**MAJOR PROJECT ASSESSMENT:
7-9 Gibbons Street, Redfern
(MP08_0112 MOD3)**

Director-General's
Environmental Assessment Report
Section 75W of the
Environmental Planning and Assessment Act 1979

October 2012

Figure 2 – Proposed External Works (highlighted in yellow)

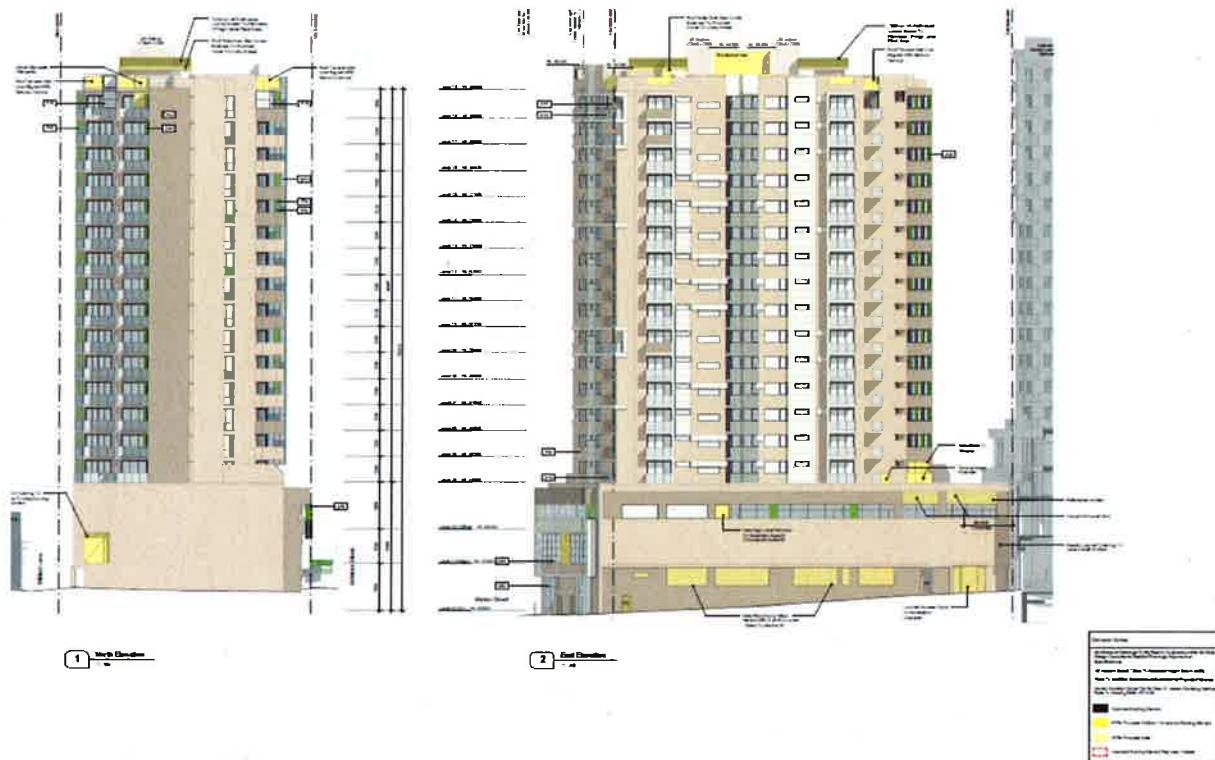
The external appearance remains largely unchanged. Initial concerns were raised in relation to the external plant due to visual impacts and consistency with the *Residential Flat Design Code*. This concern was also raised in the City of Sydney Council submission. In response, the proponent submitted amended plans which relocated the plant area within the internal envelope of the building.

The Department is satisfied that the plans depicting the plant area within the internal building envelope continue to maintain the urban design characteristics of the building. There is to be no substantial increase in the bulk of the building and the external design elements remain largely untouched.
